This is a recreated compact version of the 2023 State Electrical Code Amendment Package. The official version is located in the archives of the Building Code Council agendas. Report errors to the State Electrical Division of the North Carolina Office of State Fire Marshal. JDS 3/4/2024

Article 10 - ADMINISTRATIVE SECTION

10.1 TITLE

Figure 410.2 Exception Clothes Closet Storage Space Exception

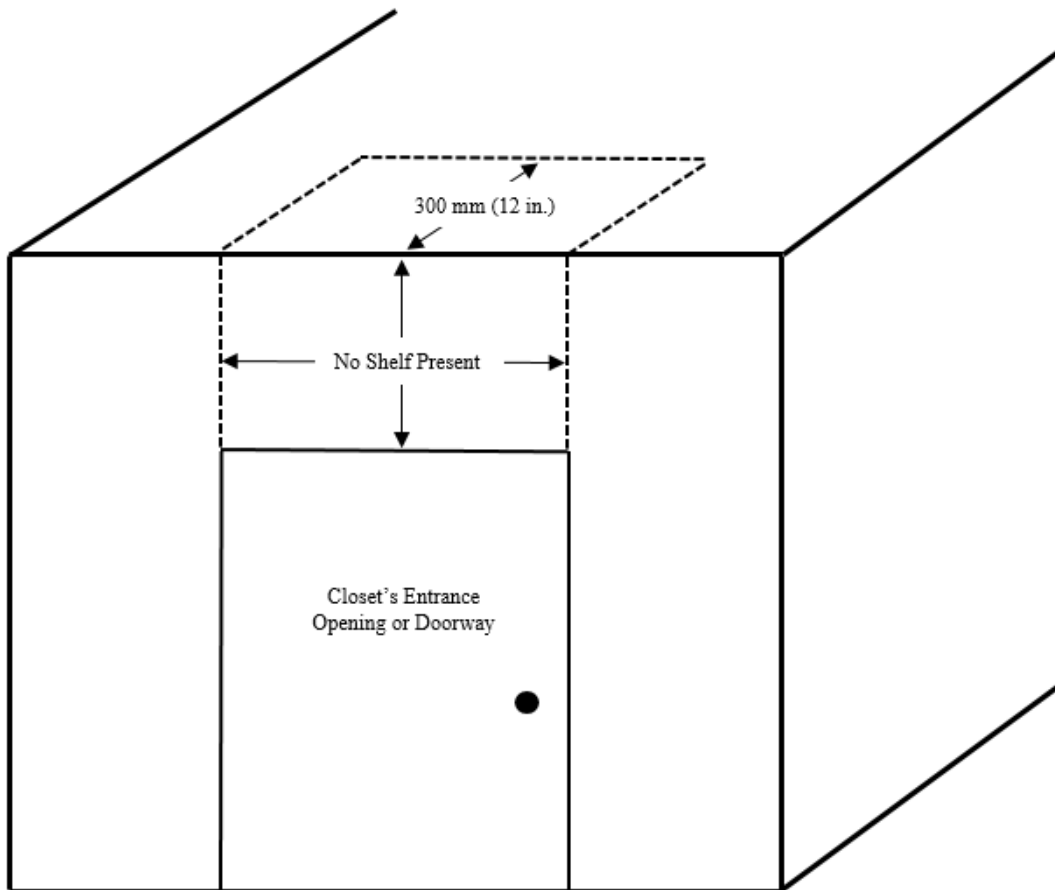
Item 23: Adding Exception to definition of Closet Storage Space in section 410.2 for clarification with NC Building Designs

Exception: Where a shelf is not present in the area of wall above the closet's entrance opening or doorway extending from the top of such opening or doorway vertically to the ceiling, including the area of ceiling extending perpendicular from the area of wall directly above the closet's entrance opening or doorway to a horizontal distance of 300 mm (12 in.), shall not be defined as closet storage space. See Figure 410.2 Exception.
